PRELIMINARY NOT FOR CONSTRUCTION BIDDING, OR PERMIT PURPOSES. FOR REVIEW ONLY. <u>QUINN G. SPANN, JR P.E. No. 6810</u> Date : <u>05/16/2008</u>

DESCRIPTION TOWN OF ADDISON, TEXAS PUBLIC WORKS DEPT. - ENGINEERING DIVISION GREENHAVEN WATERLINE RECONSTRUCTION GENERAL NOTES & MISCELLANEOUS DETAILS DALLAS, TX - FORT WORTH, TX - MIDLAND, TX - AUSTIN, TX (972) 620-1255 (817) 306-1444 (915) 689-8909 (512) 762-0542 Dallas - Fort Worth - Midland - Austin

SCALE: NOTED SHEET 2 of 5

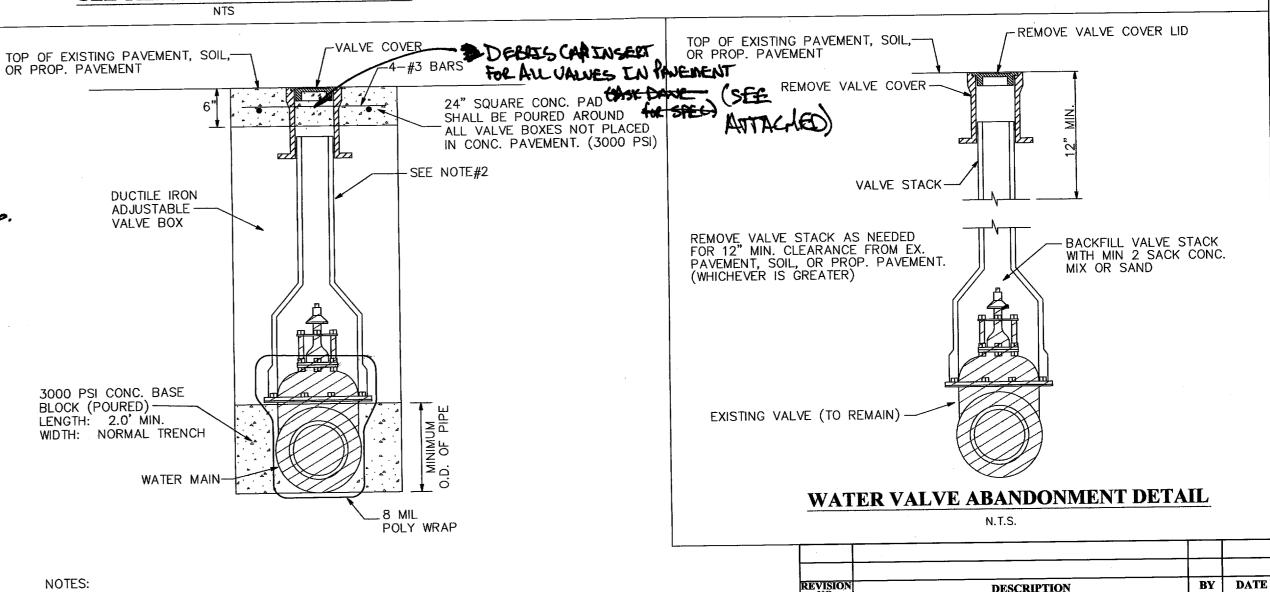
26. ALL BARRICADES AND SIGNS SHALL BE PLACED WITH THE TOWN OF ADDISON'S APPROVAL PRIOR TO PLACEMENT. Submit plan for approval.

comply with TMUTCD Part VI latest revision.
